Modification Available Performance Enhancement Service Note

N1092C DCA-M Sampling Oscilloscope

An improved extinction ratio calibration is available for DCA-M Sampling Oscilloscopes with option 30A

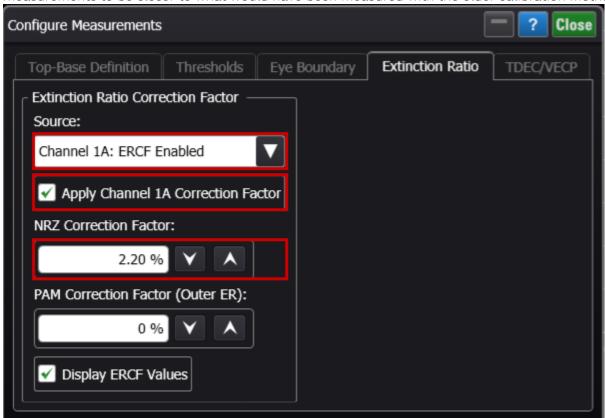
For N1092x DCA-M instruments with option 30A, units with the improved ER calibration are identified in the Help > About dialog with a "C1" annotation following the serial number.

- If the "C1" annotation is present, the unit has the improved ER calibration
- If the "C1" annotation is not present, the unit has the older ER calibration
